SECTION 8.00-9.00 Planning Pre-App’s DM/23/1480 & DM/25/0133

Responses to and Comparables with Current Full Planning/Listed Building Consent Applications

8.00 Pre App DM/23/1480 and Current Proposal Responses & Comparables

8.01 Proposed Ground Floor Extension (A1) & Library Windows (A2)

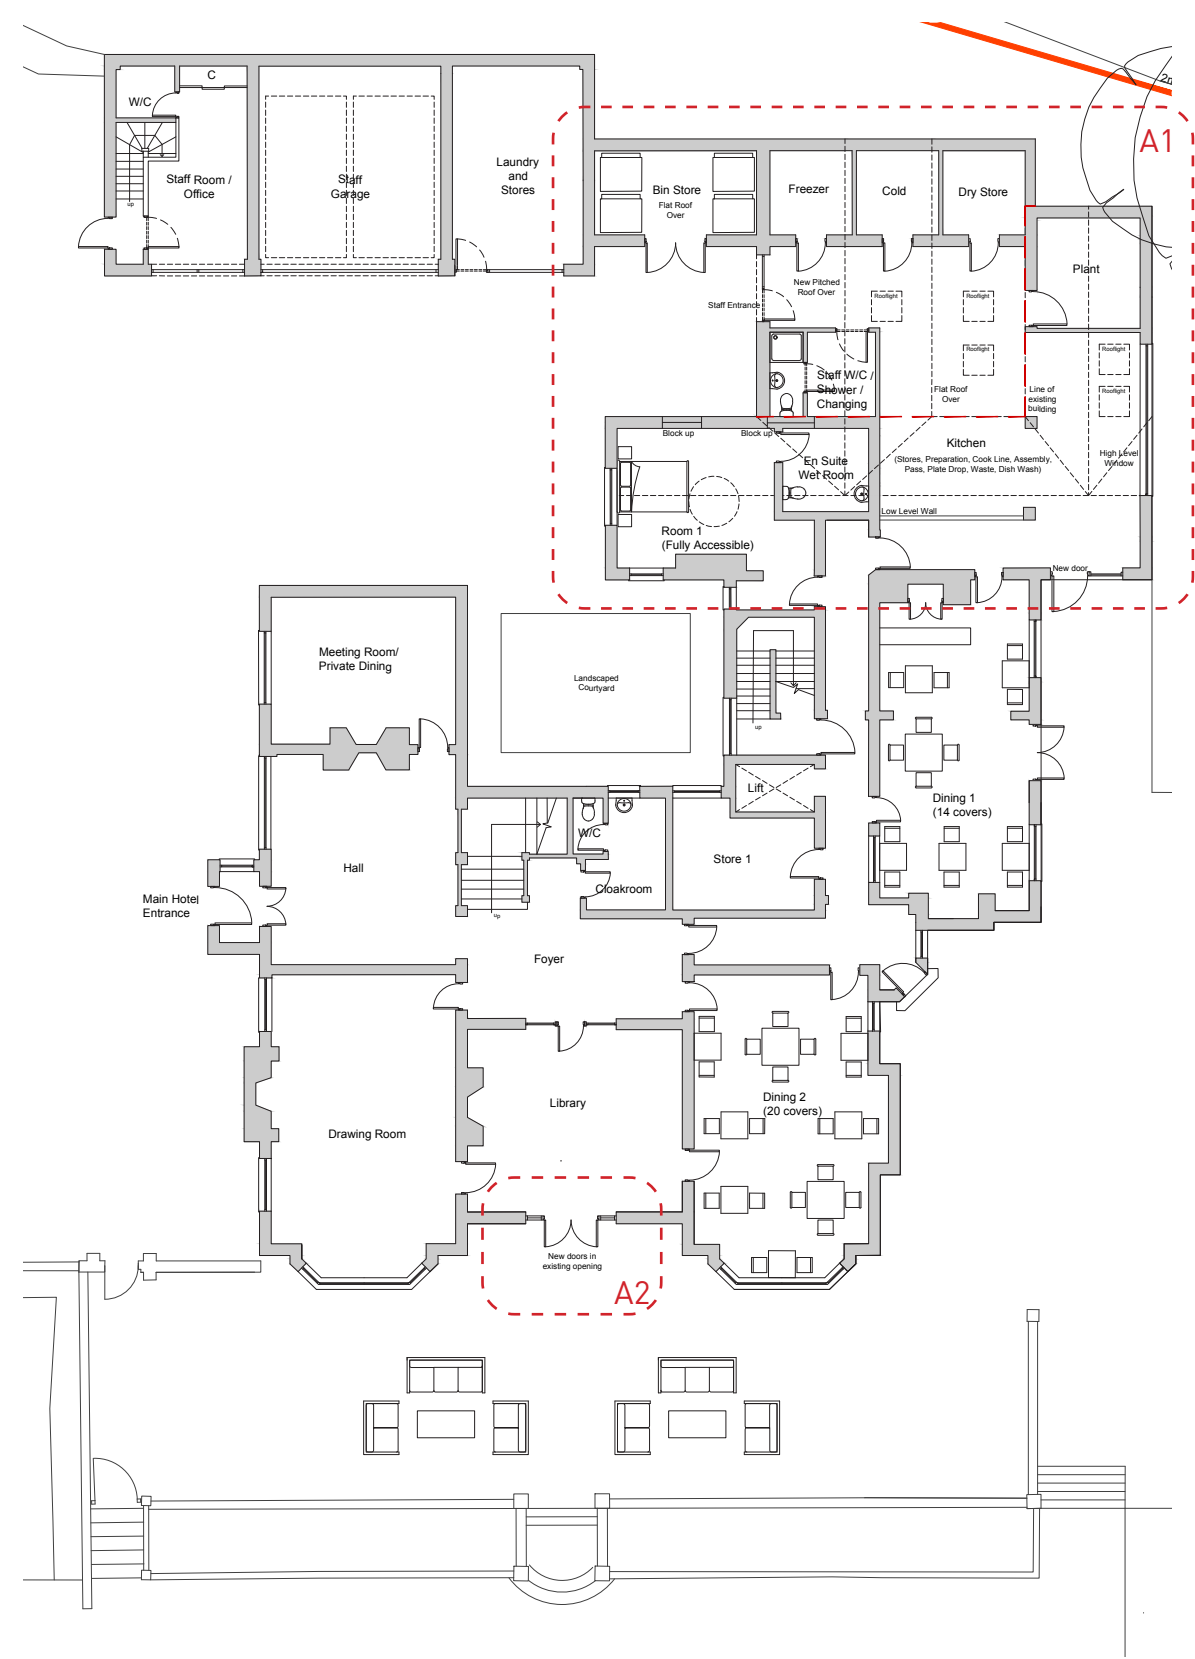
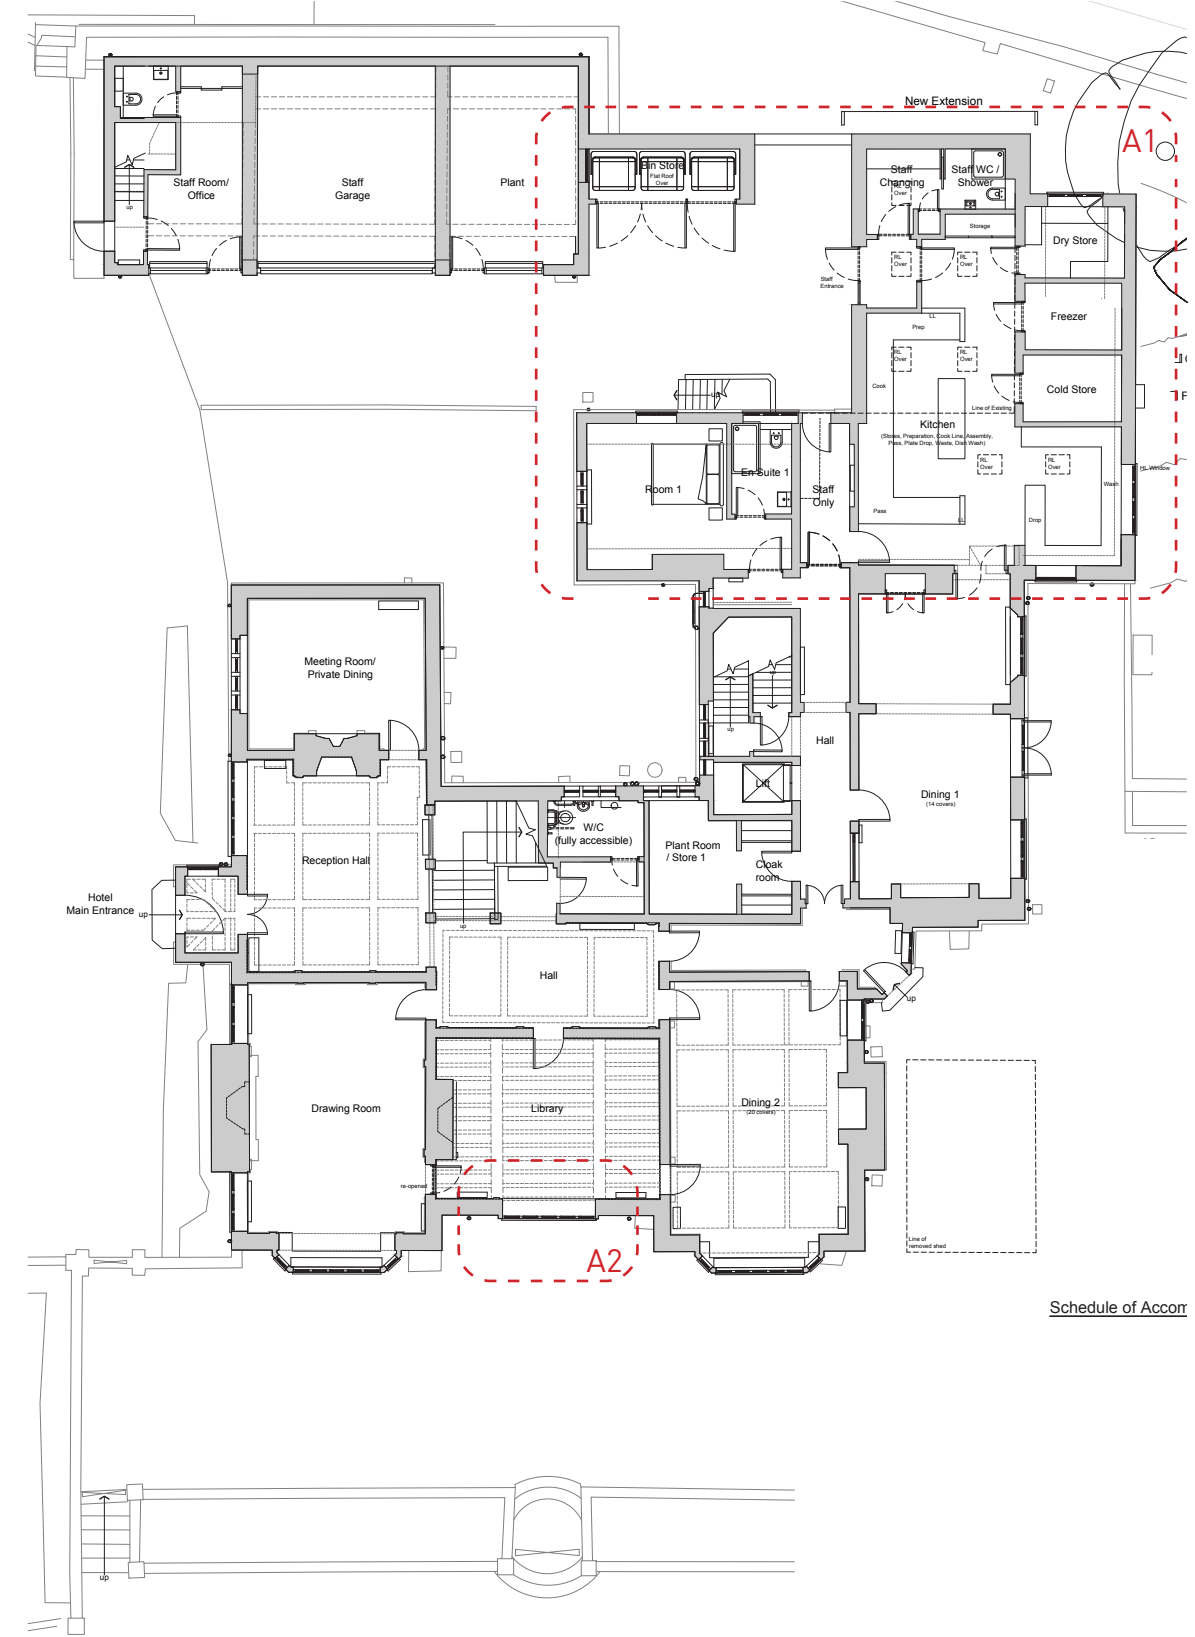
A1
“The proposed extension to the ground floor of the building is within the courtyard area to the north east of the building. This area is flanked to south and east by what appears to be the original service area/wing of the house, which while not as architecturally grand or imposing as the main part of the building containing the family rooms, is nonetheless of character and interest retaining original features such as leaded windows and doors onto the courtyard. The yard itself, with its herringbone brick pavers, is also an attractive feature of the setting of the house. Although towards the rear of the building, the yard area is visible in closer views from the main entrance drive to the house, and forms part of the context within which the main entrance façade is appreciated as one approaches the house along this drive. For these reasons I would question whether this is an appropriate position for an extension. In my opinion, a kitchen extension might be better positioned to the opposite side of the existing service wing (currently containing a gym), which although it would be visible from the terrace to the south east of the house, could if appropriately set back in relation to the main building (as the existing wing is), be appropriately subservient in views of the house from the terrace and gardens, and would allow the character of the courtyard facing elevation, which is in fact probably the more significant in terms of the context in which the house is appreciated, to remain largely intact, as well as the courtyard itself. In conjunction with this I would not object to a more modest extension to the northern end of the existing kitchen wing linking across to the modern garage building, providing this preserved the key features of the wing, and the character of the courtyard space.”

A2
“During our site visit we noted that the existing windows to the library are original, and the original fabric beneath them both internally (wood panelling, part of the designed decoration of the room) and externally (a stone plinth). The existing window is also part of the designed composition of the elevation. For these reasons I consider that the proposal to remove the fabric below the window sill, and replace the existing windows with French doors, is contentious, and will detract from the special interest of the listed building. This aspect of the proposal should be omitted from the formal scheme.”

A1
Whilst the comments of the LPA re. the pre-app proposal for the repositioning of the extension to the East of the listed building (in close proximity to the new spa and pool building) are acknowledged, there is a clear rationale for the positioning of the new extension to rear (North East) of the main building as cited opposite. However, mindful of the comments made, the overall size of the proposal has been reduced by c25Msq (c. 40%) in order to limit any perceived impact on the listed building.

A2
The comments of the LPA re. the pre-app proposal to remove the bay window and fabric below the window sill and replace with French doors are acknowledged and have been omitted from the current scheme. This area will therefore remain as existing.

8.02 Proposed First Floor Bedroom 4 & 5 (B1)

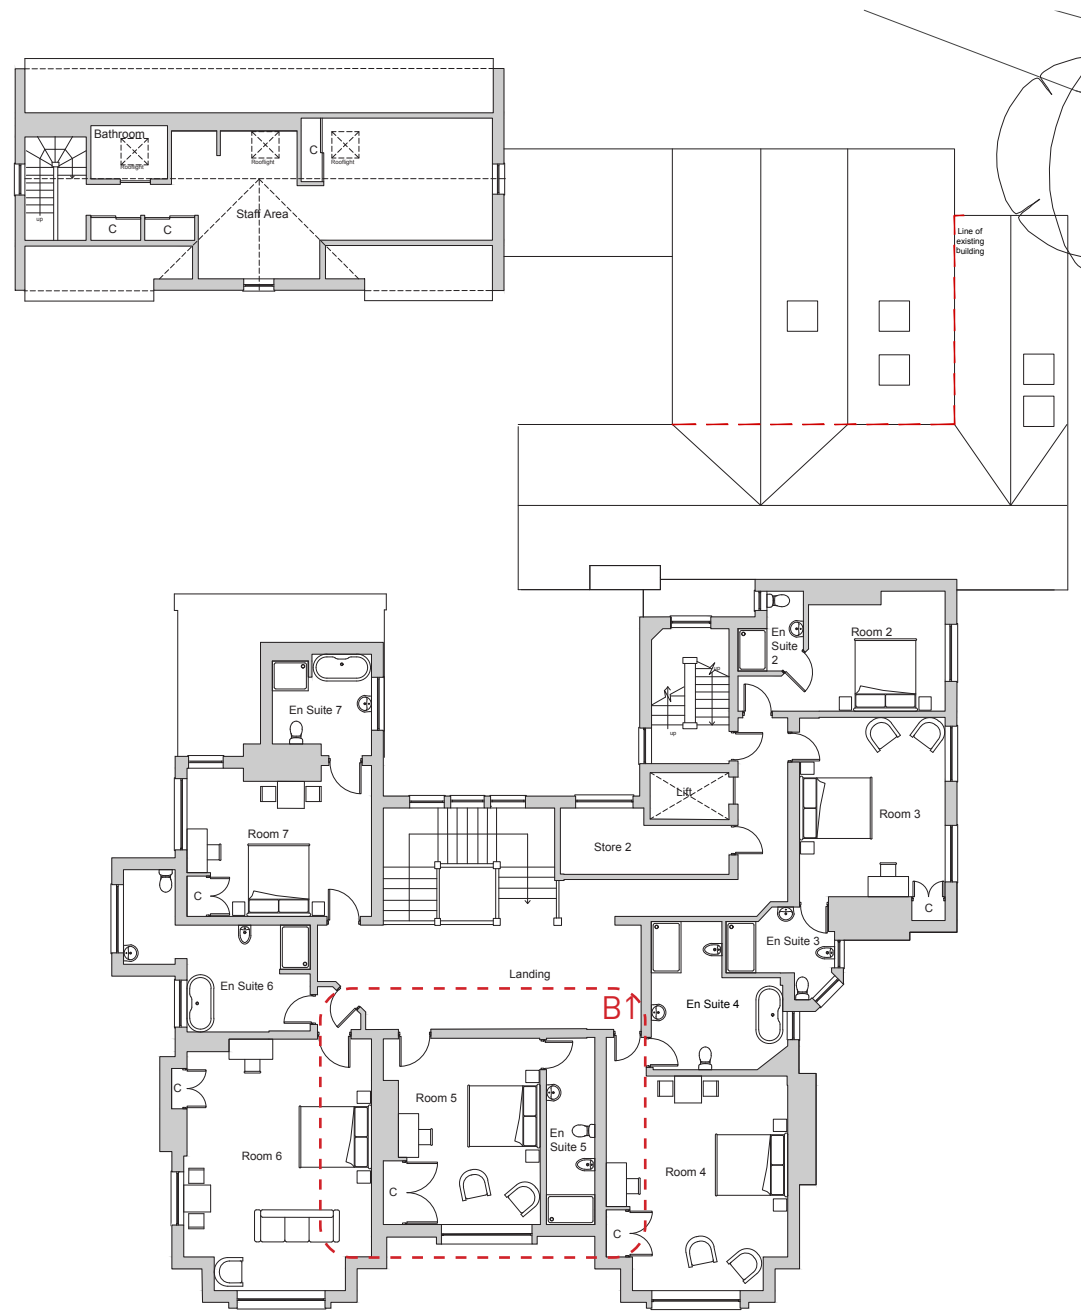
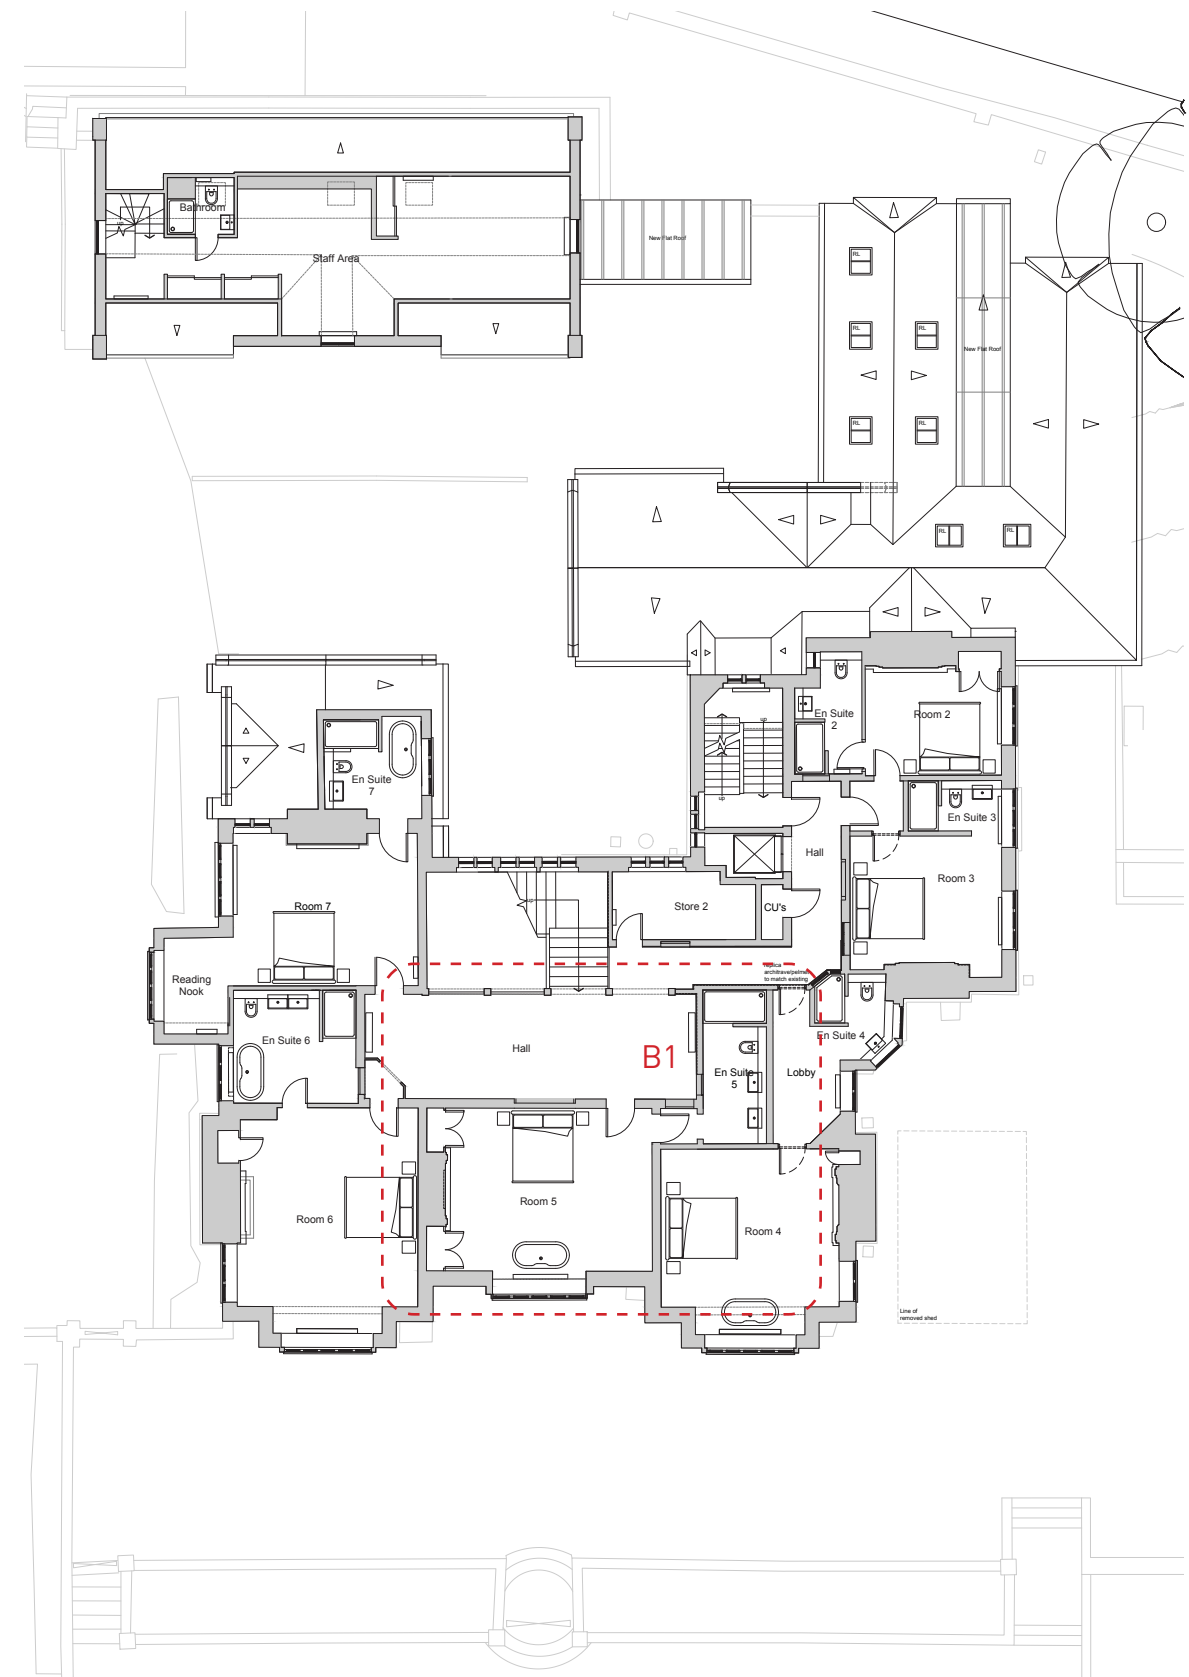
B1
"At first floor, the alterations to the existing floor plan are in general relatively minor in their impact, and are not considered contentious subject to detail in light of the existing permission. This is with the exception of the proposed works to bedroom 5, which involve bisecting the room by the insertion of an ensuite. This room is one of the principle family bedrooms, and the adverse impact on its original proportions which would result from the proposed work would in my opinion unacceptably impact on its character. This aspect of the proposal should be reconsidered- potentially the room, which is already linked with the adjacent master bedroom, could be incorporated into a suite with that room?"

B1
The comments of the LPA re. the pre-app proposal to insert an en-suite shower room into principal room 5 and bisect the space have been addressed with re-design to suit.

The current proposal maintains room 5 as existing, retaining its original features, cornicing, skirtings etc insitu including its entrance door from the landing (previously repositioned). The adjacent dressing room and ensuite to existing bedroom 4 is adapted to form a lobby, accessed from a new entrance door within the panelling of the hallway to match all other doorways on the landing area by replicating panelling, architrave, over door frieze and door / ironmongery to match existing complete. The new en suite is positioned off of the lobby (in the position of the existing en suite), modified to suit new layout to bedroom 4. The remaining part of the original dressing room is proposed as bedroom 5's ensuite.
